Appendix B
Applicant's Parking Analysis and Correspondence

Re: Clarksburg Town Center – Supplemental Site Plan Information

**CLARKSBURG TOWN CENTER
11/20/08 ADDITIONAL INFORMATION SUBMISSION TO M-NCPPC**

**PROPOSED NEW RECREATIONAL FACILITIES COMPLIANCE TO RECREATIONAL
GUIDELINES**

Design Concept - PLAN "A"
APRIL 11, 2008

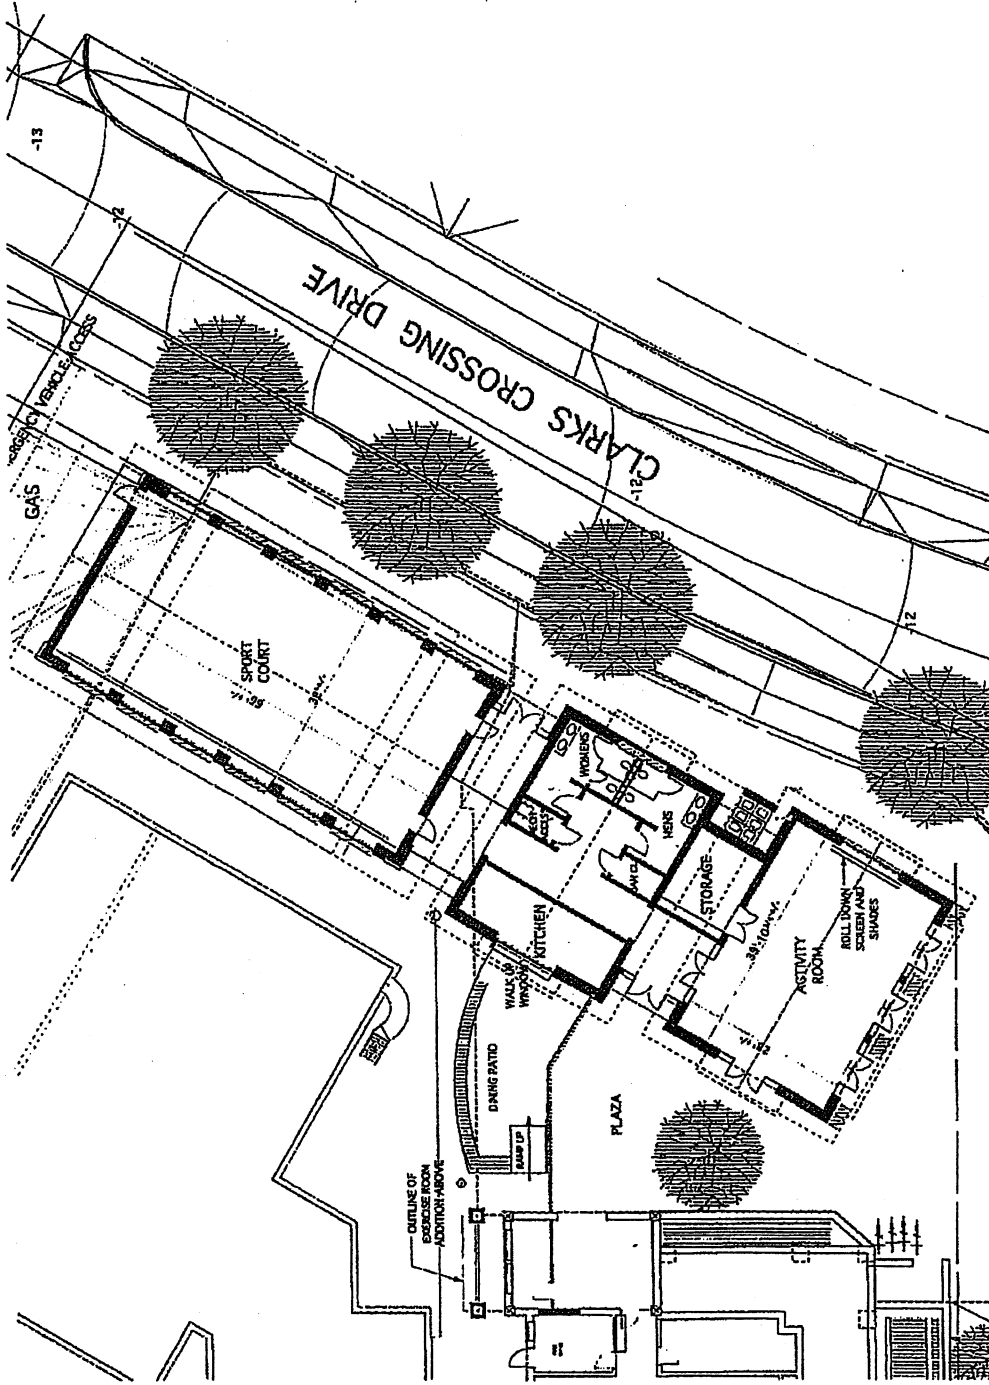
Planning Staff recommended, in its October 23, 2008 Staff Report, replacing the year-round, two-lane indoor lap pool and the 800-square foot snack bar building (both called for in the Plan of Compliance) with an all-sport court. In response, the Applicant provided Staff with a design concept dated April 11, 2008 ("Plan 'A'"). During the November 6, 2008 hearing, there was some discussion regarding further community input. As a result of comments provided by the HOA Pool & Recreation Committee an alternate design concept is submitted for staff review ("Plan 'B'"). Plan "A", HOA Pool & Recreation Committee review comments to it, and Plan "B" are attached for reference as Attachment 1, Attachment 2, and Attachment 3, respectively.

The Applicant prefers Plan "A" over Plan "B" for the following reasons; 1) the sport-court is considerably closer to the recommended M-NCPPC guideline, 2) the larger sport-court affords greater flexibility in the activities that can be accommodated, 3) its construction will be less disruptive to the use of the existing facility, 4) the ceiling height of the community room better accommodates movie projection, if desired, and 5) more direct handicap accessibility is provided to the building addition. However, the Applicant is willing to construct either improvement as required by the Board.

Plan "A" and Plan "B" provide for a sport court with approximate interior dimensions of 32-ft. x 66-ft. and 25-ft. x 47-ft., respectively (these dimensions are subject to change during preparation of the permit/construction documents). Due to site constraints, Plan "B" cannot provide a larger sport-court.

PLAN "B"

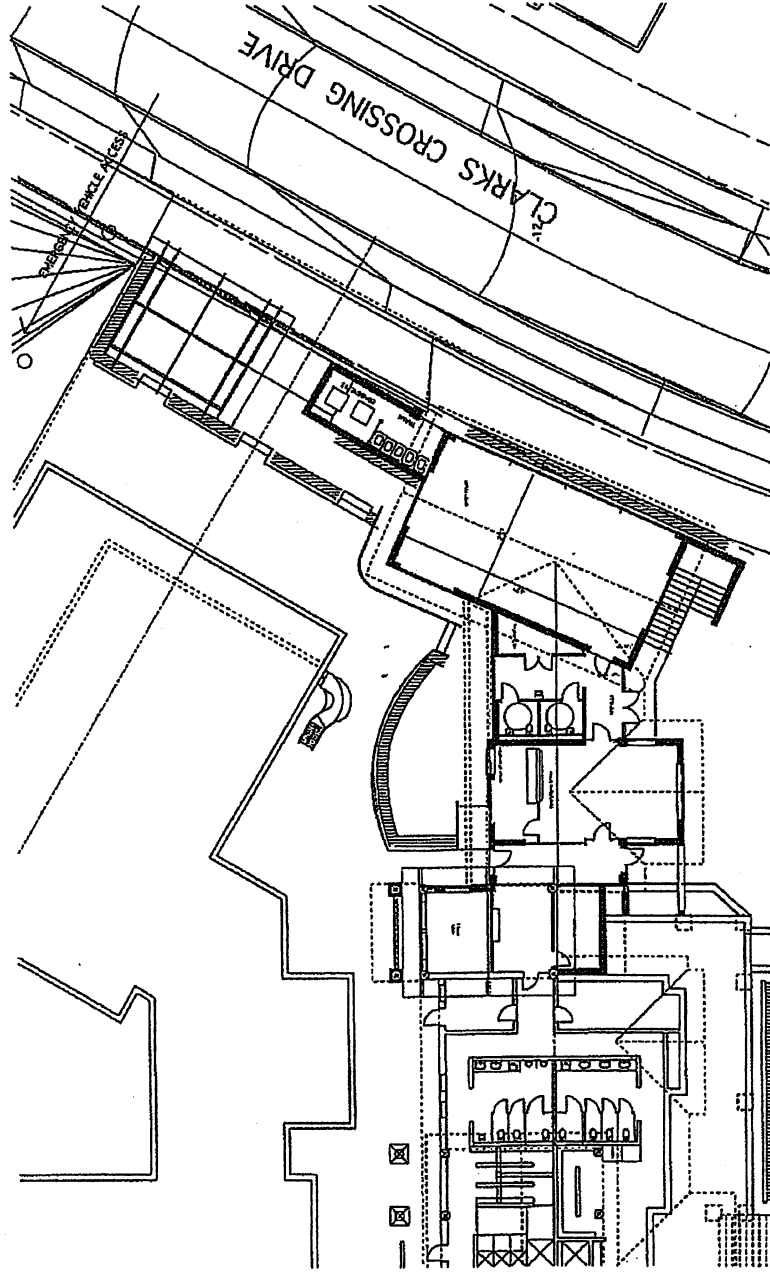
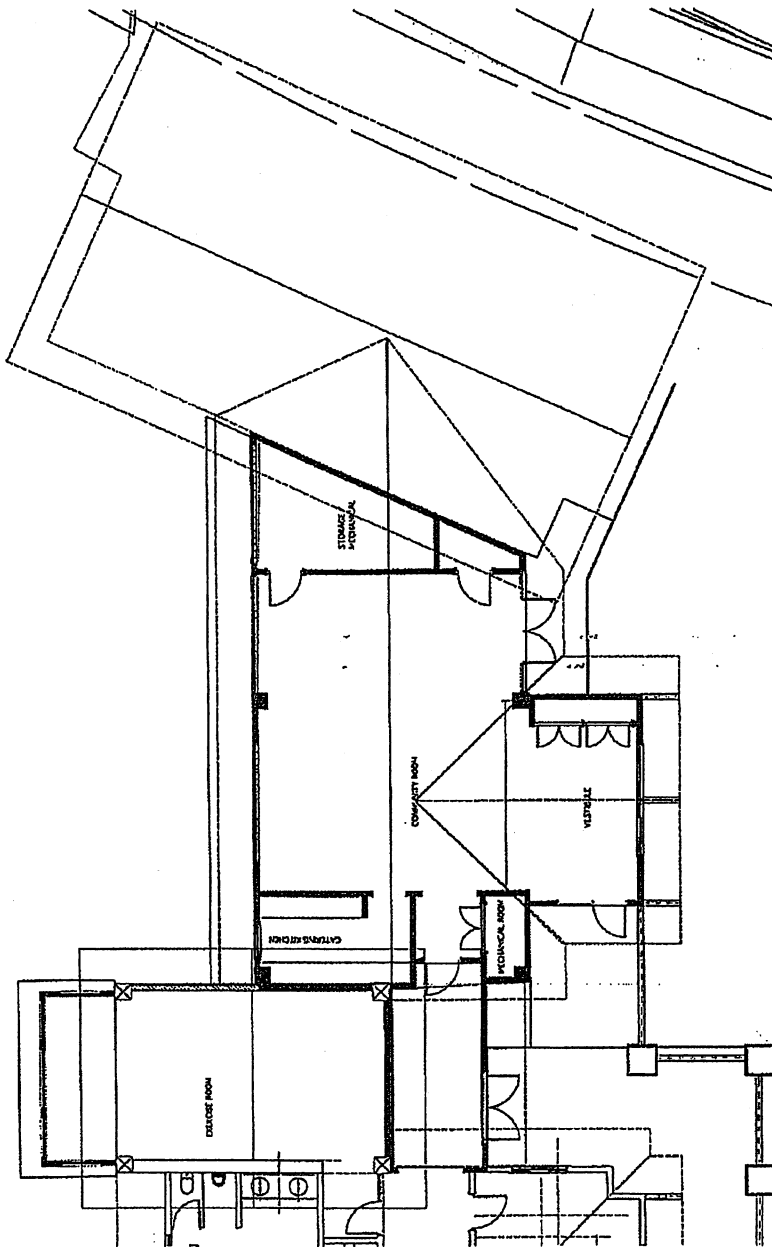
I would like to clarify the sport court item. None of the plans we saw had a "full court" sport court and we did much prefer the plan with the extension on the existing building, even though it had a smaller sport court.

March 19, 2008 Revised November 20, 2008 to include required fire egress stair

UNITED METHODIST
 CHURCH STAIRS
 ODLA - 1" = 10'-0"

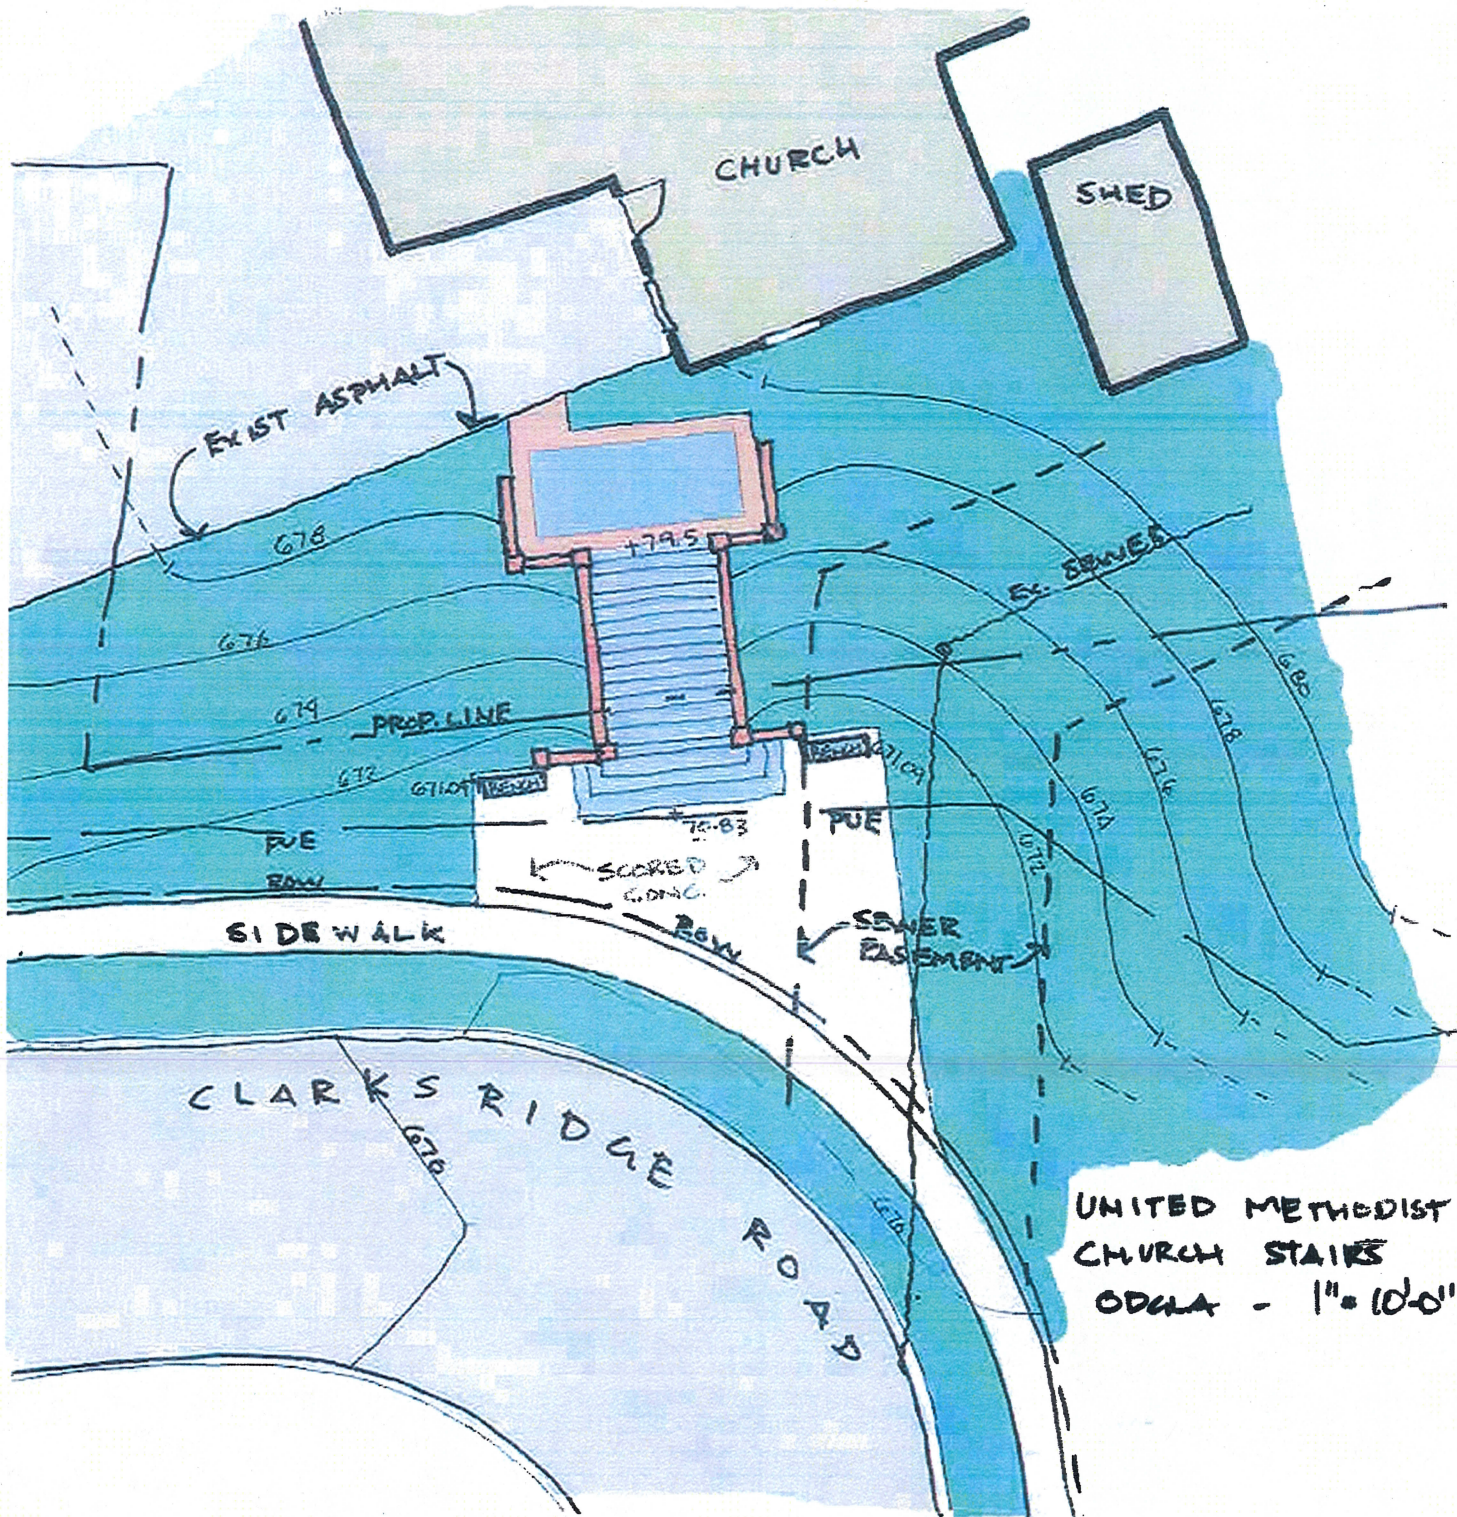
Item 7aa. Applicant must clarify why the LOD extends out into afforestation areas Z and HH on Sheet 37.

Item 7bb. Applicant must clarify why the LOD extends out into afforestation areas Z and HH on Sheet 37.

DISCUSSION: We clarified that these areas were included in the LOD because there will be temporary sediment traps in these locations. The final disturbance will not be within the afforestation area. M-NCPPC requested that none of the afforestation be south of the utility easement running through the center of the site. With the reduced amount of plantings required we don't anticipate this will be an issue.
